GENERAL ELECTRIC

MODELS RC1611A, RC1616A, RC1616B

RC1611A & RC1616A SCHEMATIC DIAGRAM

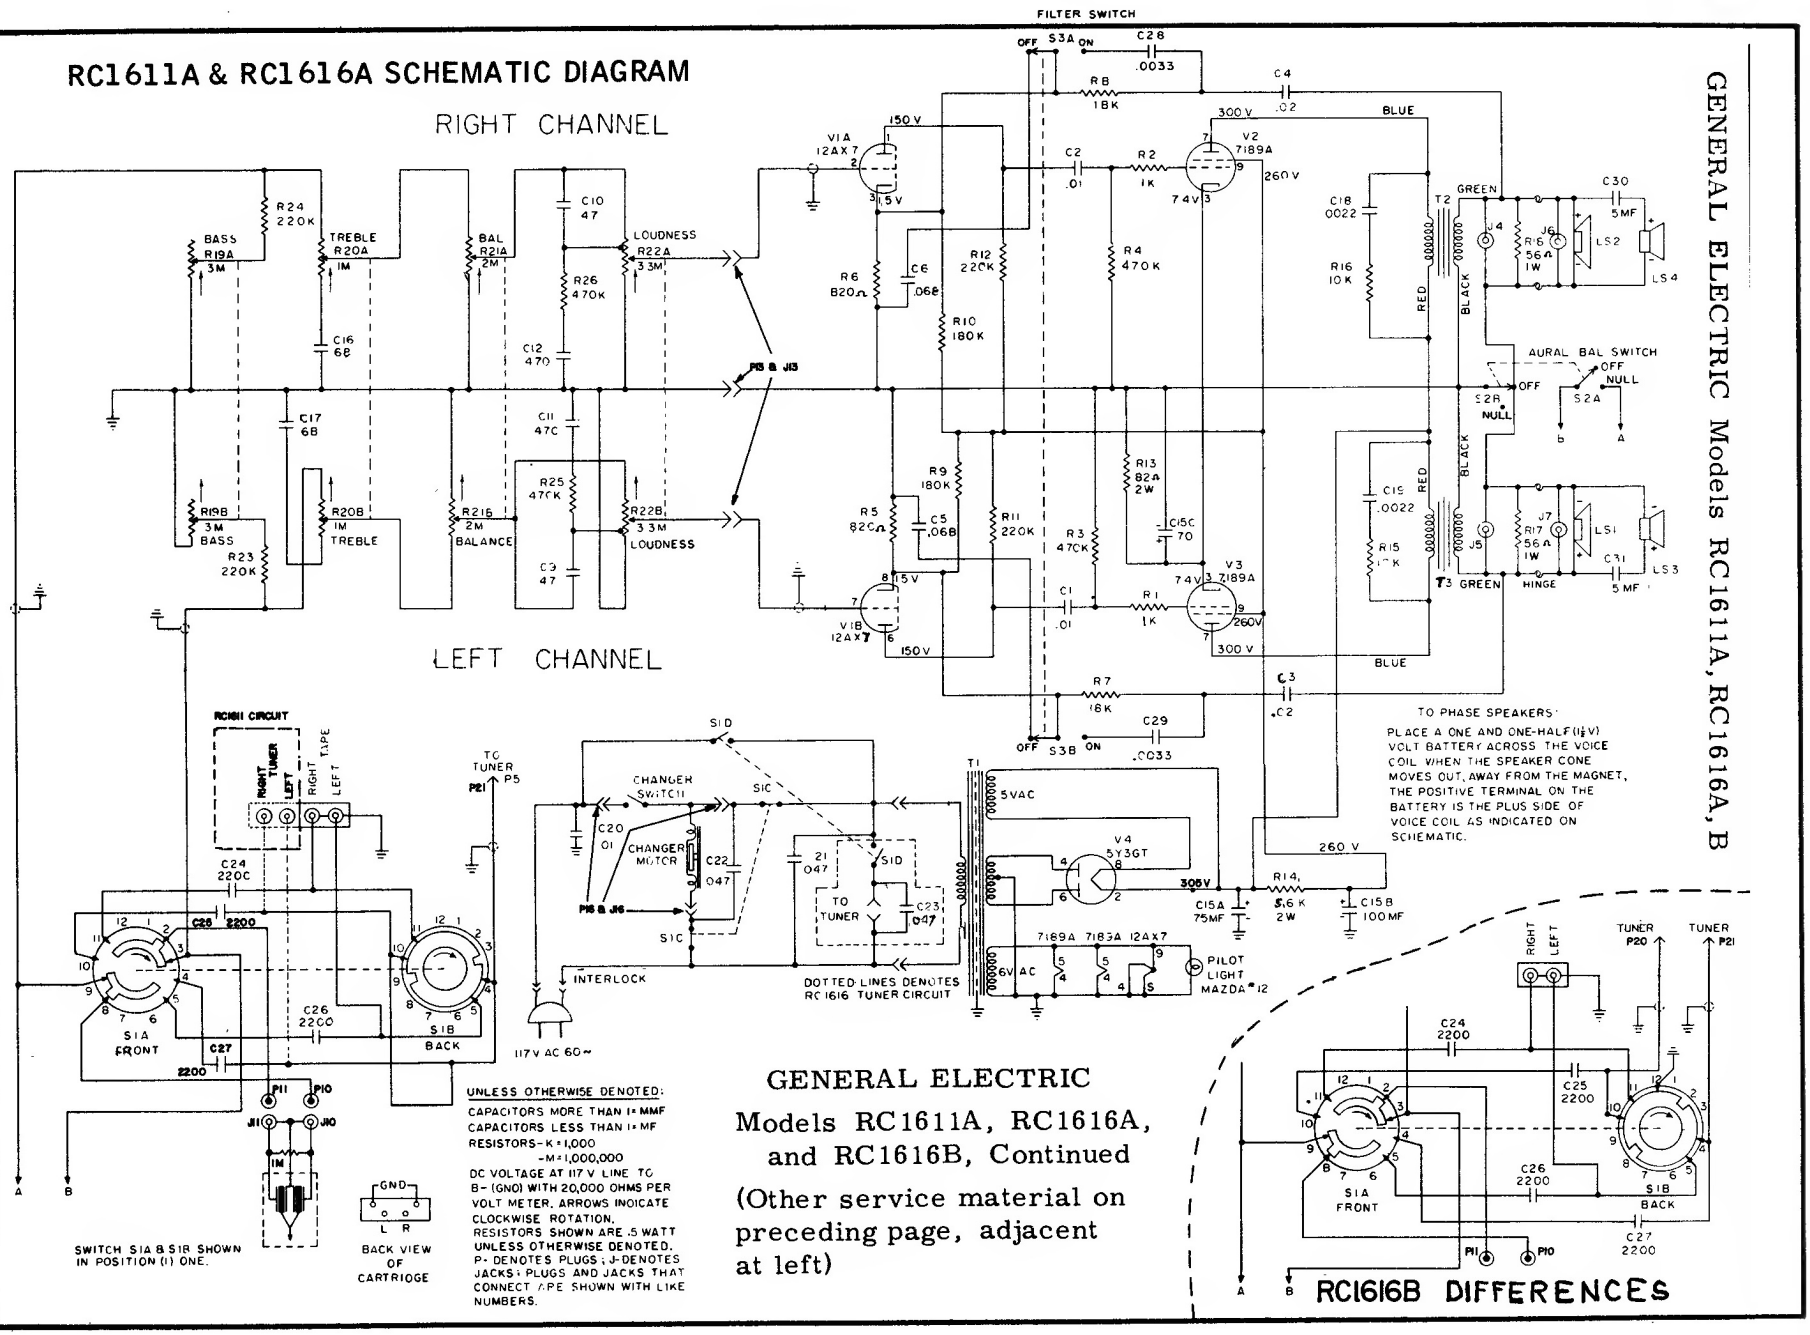
TUNER - The RC1616A series used the TU-20G tuner and the RC1616B series used the TU-20C tuner. The difference between the tuner models is the type of selector switch used. The TU-20G utilized a three position selector switch (AM, FM, FM-AFC) and the TU-20C tuner used a four position selector switch (AM, FM, FM Stereo, and FM-AFC). The FM-AFC position on the TU-20C tuner is actuated by a push-pull switch mounted on the selector control shaft. This places the FM stereo switching on the TU-20C tuner selector and changes the RC1616B function control switching to PHONO-OFF-TUNER-TAPE. This required a small wiring change to the function switching circuit as shown in the RC1616B schematic.

A modification to the scratch filter circuit has been incorporated in the RC1616B series beginning with serial number K294001. It results in the elimination of four cables to the scratch filter switch and better component assembly in the power amplifier.
